## CCPS RFP#25-04 – NORTH EAST MIDDLE/HIGH SCHOOL REPLACEMENT PROJECT

### ADDENDUM #7

**This addendum is to provide the pre-bid agenda and attendance list and issued revisions to the contract documents as noted below.** Proposers and related parties will be responsible for reading and understanding all documents, the scope of work, addenda and all related solicitation documents issued. These documents will become attached to and part of the solicitation and award of bid contract.

1. **ASIs 01 and 02**
2. **PR 01**
3. **CLOSED RFIs 001- 0027, 029-031, 034. (open RFIs are excluded)**

- [A423](#)

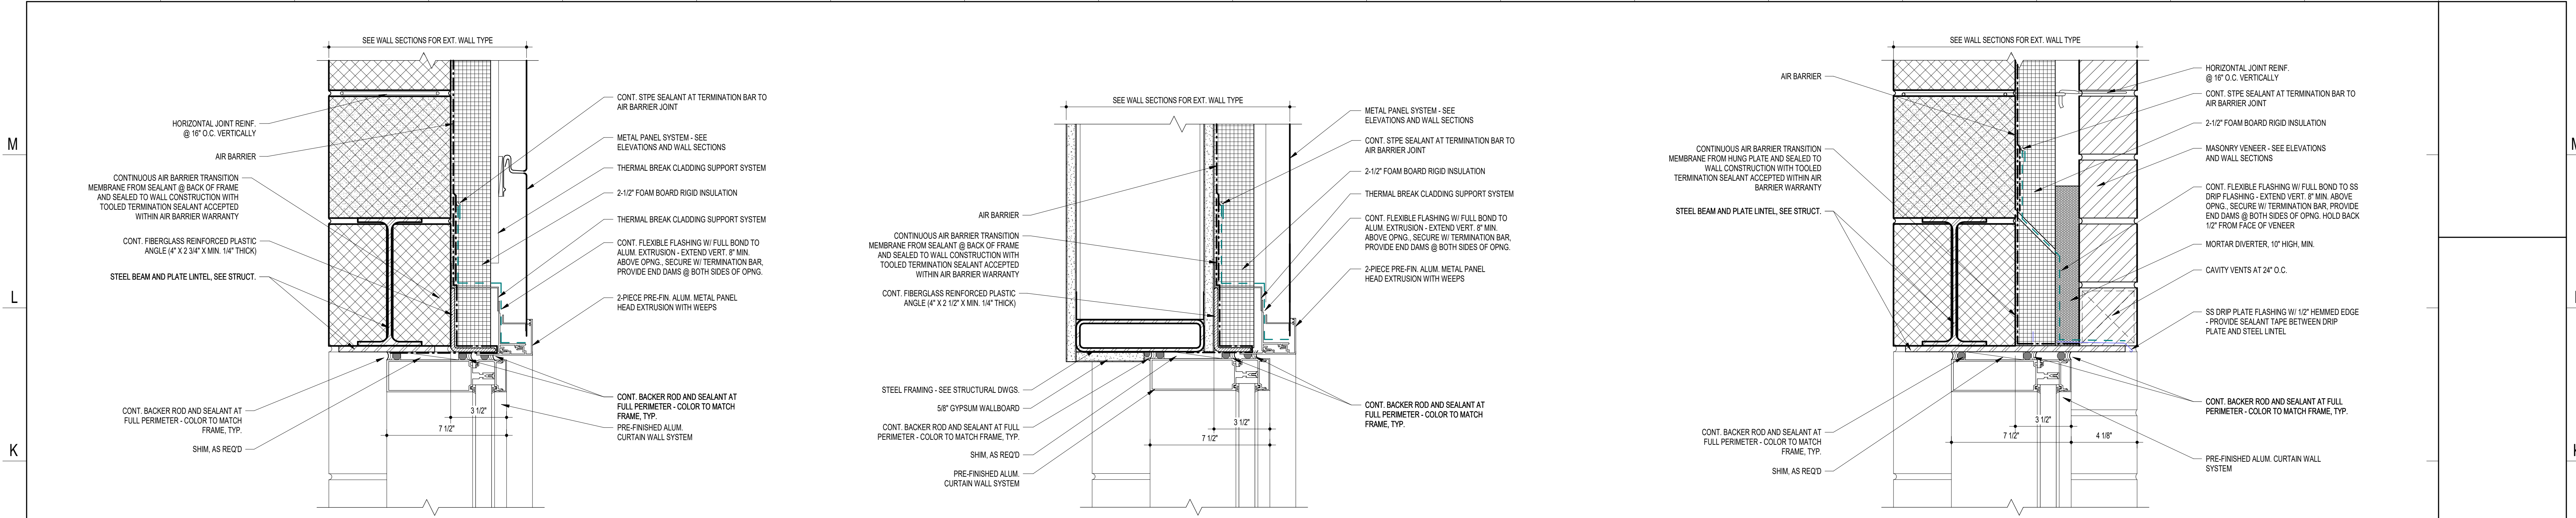
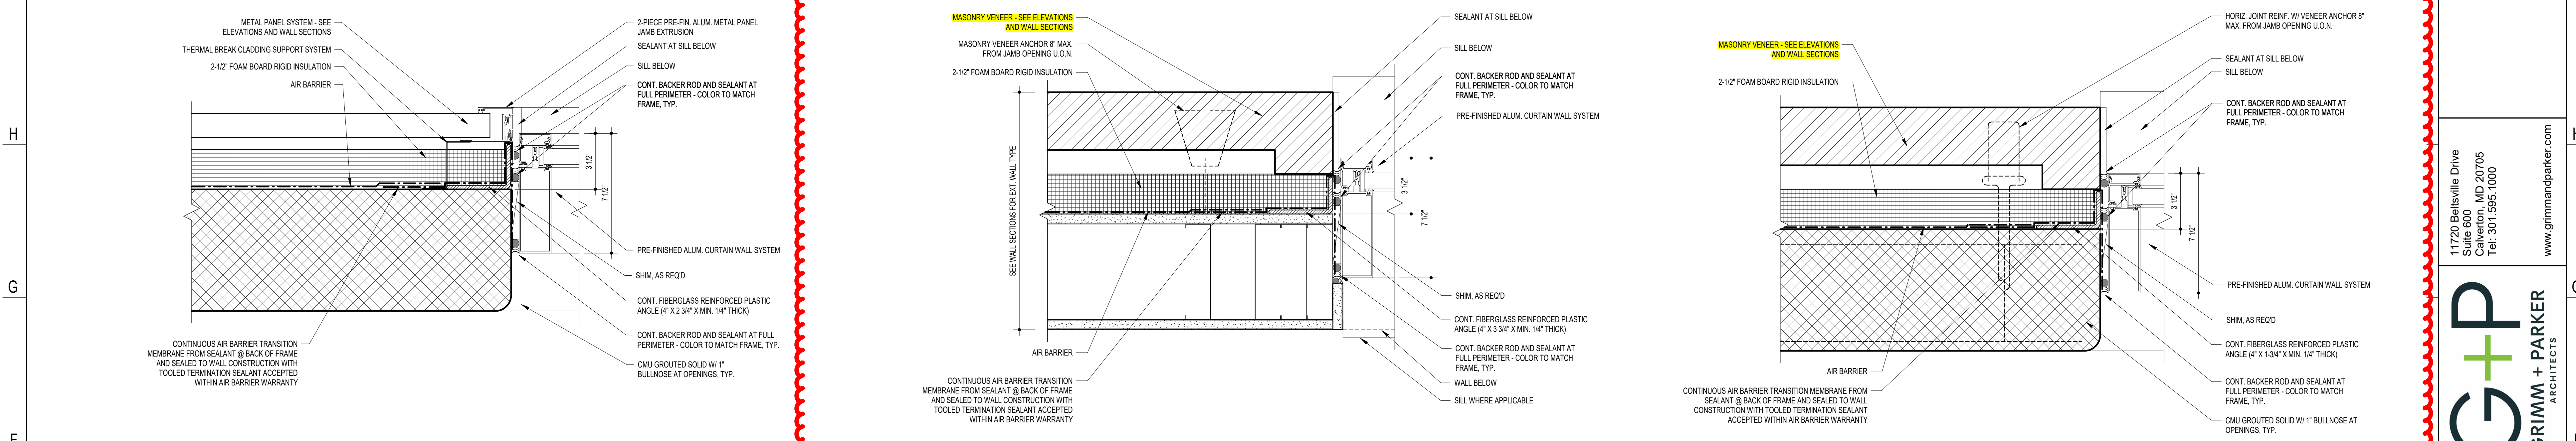
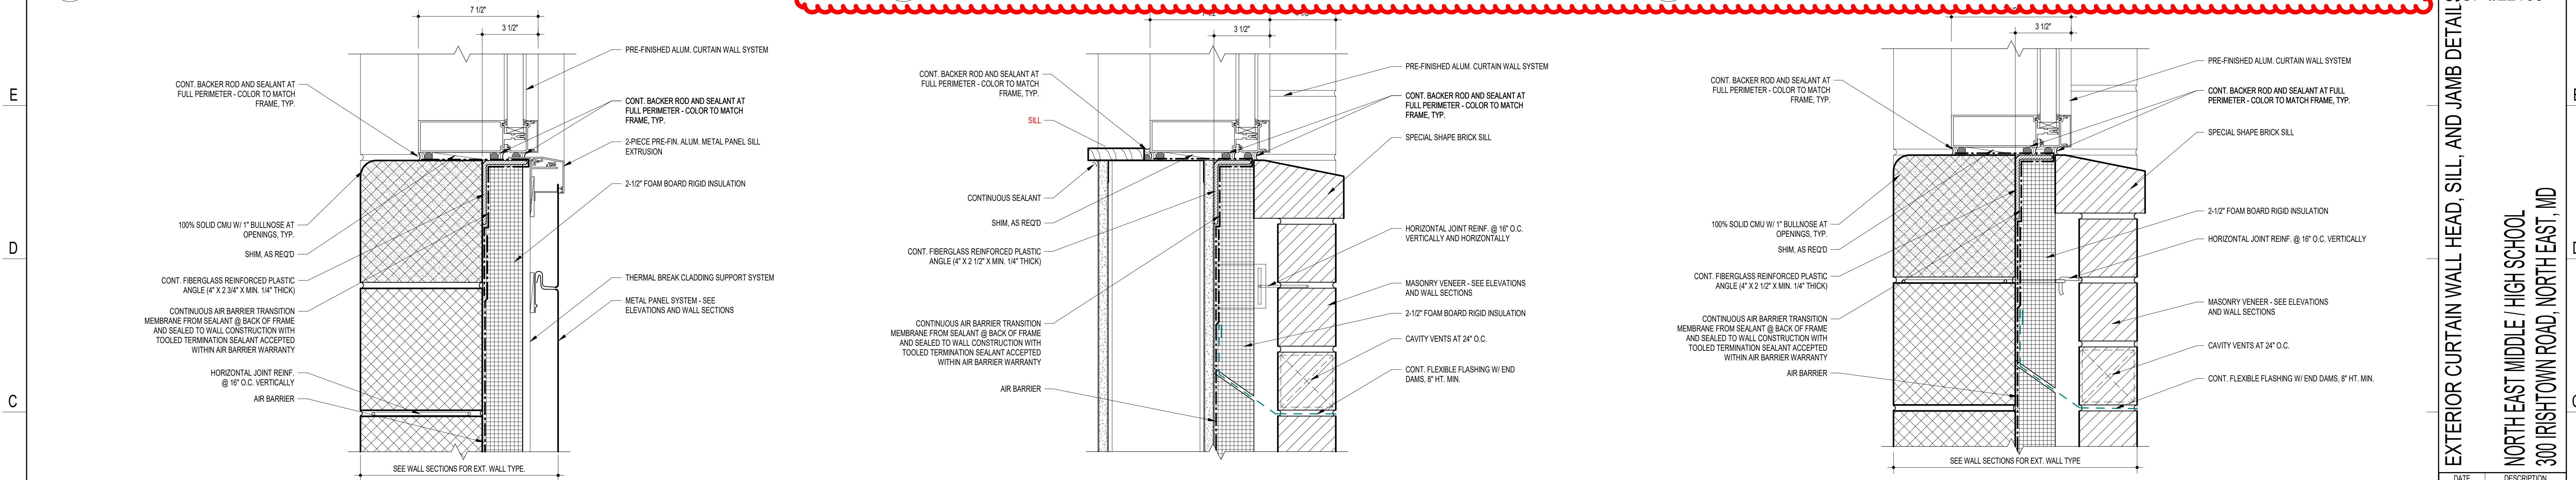
Details B6 & B12/A423 show the back of special brick shape sills abutting the fiberglass reinforced plastic angle. Please advise if these brick should be shifted out 1/2" to provide space for differential movement to avoid brick being pushed loose over the life of the building.

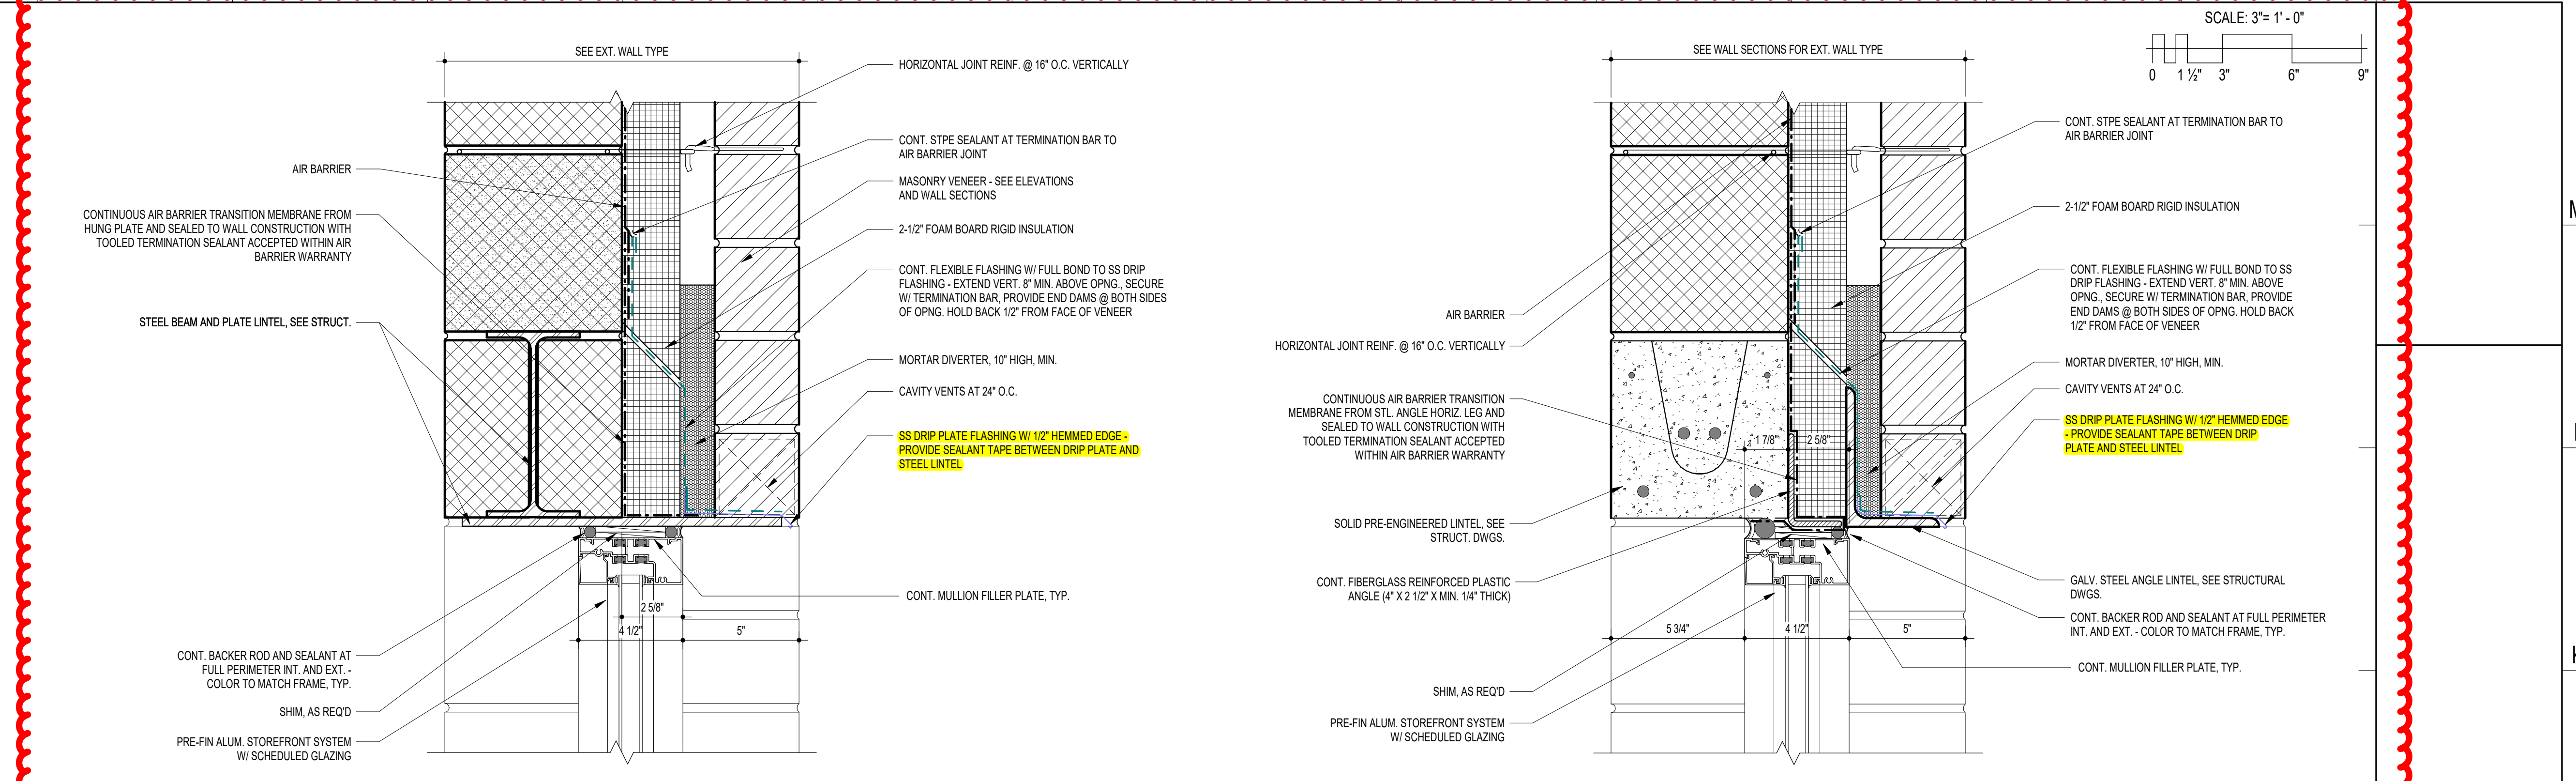
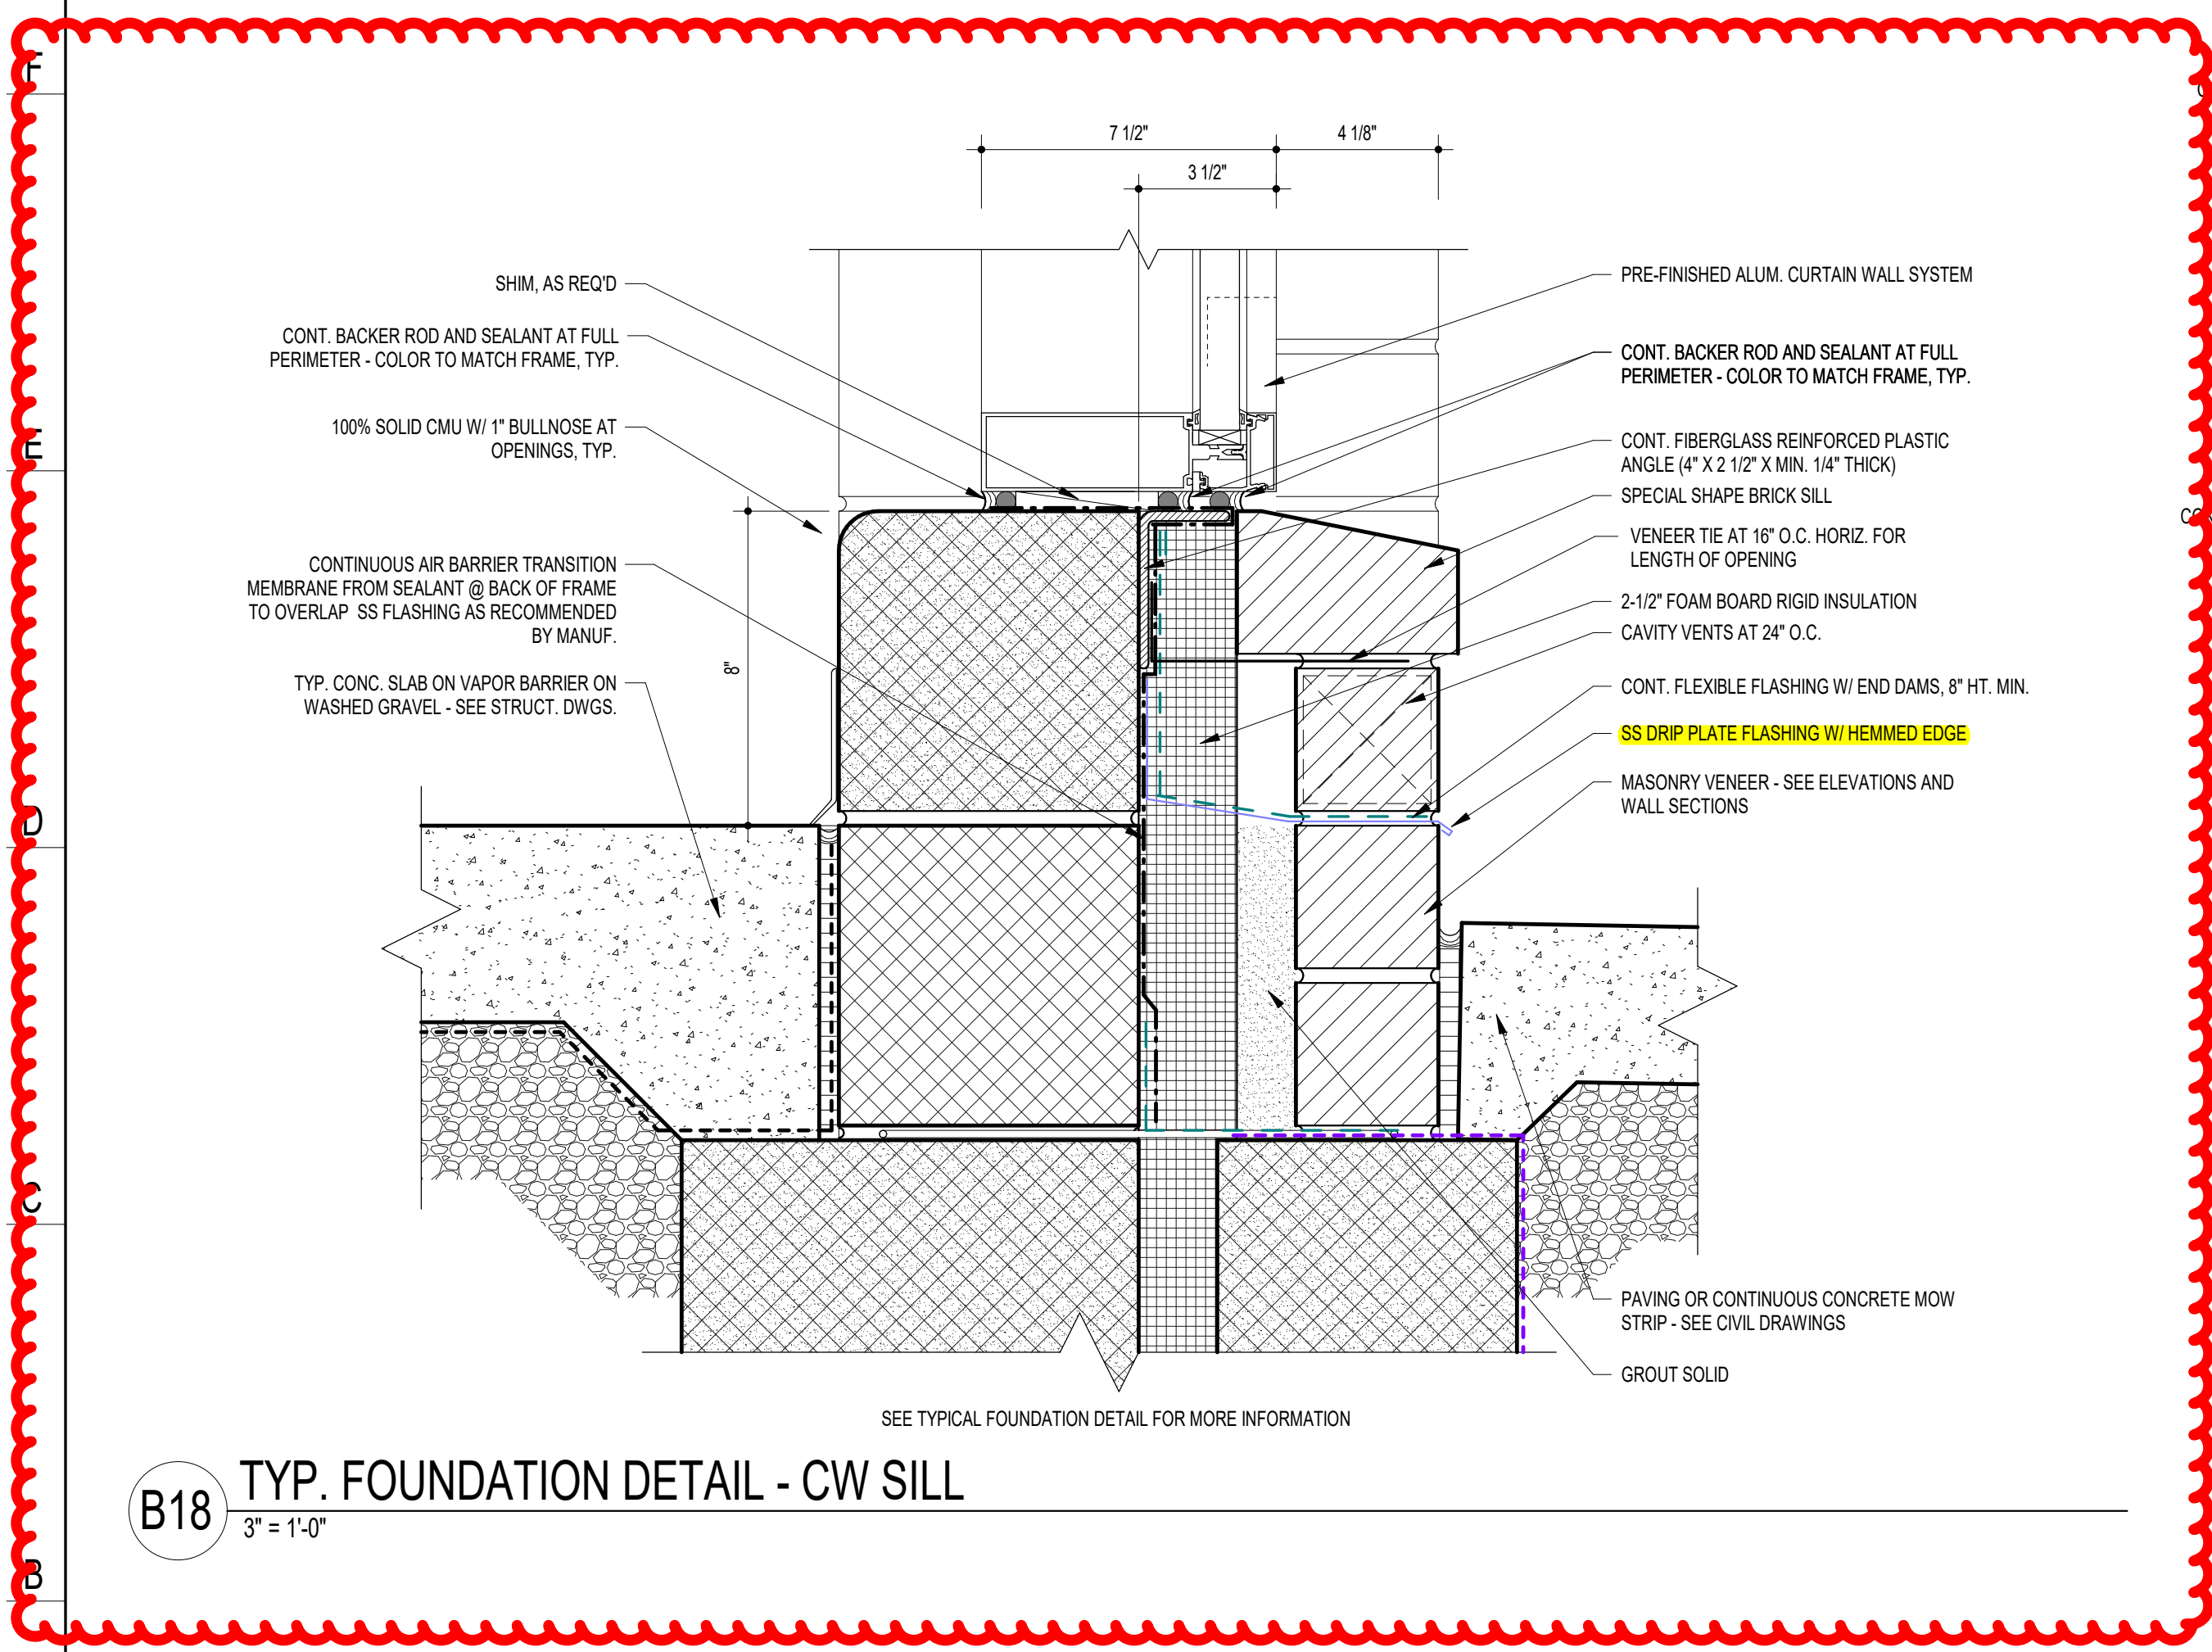
- Typical fenestration details on sheet A422 call for "sealant tape between drip plate and steel lintel," however no product is specified in section 042000. Drip plate will be sealed to steel lintels with the same sealant/mastic used to lap seams in the flashing. Please confirm this meets the requirement and additional sealant tape is not required.

- Details B18 & J12/A422 (and other similar) show "SS Drip Plate Flashing W/ Hemmed Edge" running from face of brick, through the cavity (with solid grout or steel below) and turning up the substrate with continuous flexible flashing on top. However, other typical through wall flashing details on sheets A422 & 423 only show the continuous flexible flashing spanning the cavity (without support from grout below). Please confirm the drip edge in details B18 & J12/A422 can be reduced to 3" deep as long as flexible through-wall flashing is fully supported.

- Several details on sheets A422-427 do not always show SS drip plates at face of brick veneer, but spec 042000 2.7 B 3 calls for a drip edge where "flashing is partly exposed and is indicated to terminate at the wall face." Please confirm SS drip edge shall be used at all masonry through wall flashing locations unless a roofer's reglet (or sim.) is required.

1. The preformed silicone extrusion is required at joints where there is a change in substrate, CMU expansion joints, gyp sheathing vertical expansion joints, masonry expansion joints between CMU and concrete, etc. See details on sheet A427.
2. See attached basis-of-design product from York Flashings - UniverSeal US-100 Liquid Tape, or approved equal.
3. Both the Weep-Armor and Weep-Net are required. The Weep-Armor is installed first (see attached cut sheet) and the Weep-Net rests on top of the Weep-Armor.
4. No. Install drip edge per details.
5. Paragraph 2.7.B begins with "UNLESS OTHERWISE INDICATED...". Install the flexible flashing as detailed on the contract documents.
